Product Change Notification

Date Issued :	October 10, 2023	PCN Number :	514416
Reason for Change :	Equipment Transfer, Production Transfer or Rearrangement		
Description of Change :	This notification is to inform you of molds and Assy line transfer that have been issued to manufacture the affected part(s). This PCN is due to where the demand is located and desire to local to local supply. The molds and Assy line have been moved to another location/site/facility from Chengdu to Guad 2. We are starting these transfers in later Q3 2024. No product changes will be made as part of this change.		
Assessment of Change :	No change to parts - Form/Fit/Function		
Planned Implementation Date :	August 01, 2024		
Sample Availability Date:	June 14, 2024		
Internal Molex Qualification Date :	June 14, 2024		
Last date to request Samples by Customer :	June 04, 2024		
Traceability Code Markings / Date :	Date code

Guadalajara 2

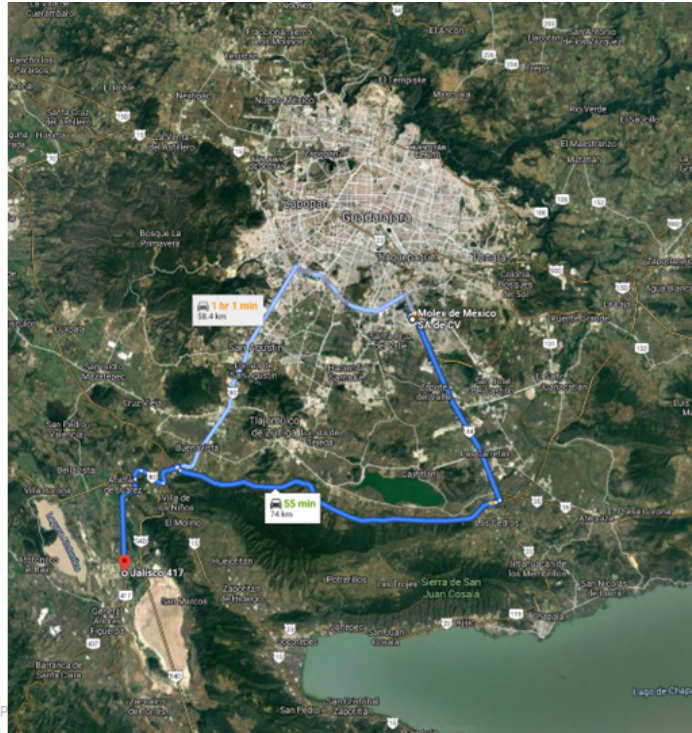
- Located in Centro Logistico Jalisco Industrial Park
- 1 hour from existing Guad1
- Initial build will contain Molding, Assembly, and Reliability Testing capabilities
- A new Distribution Center services Guad2
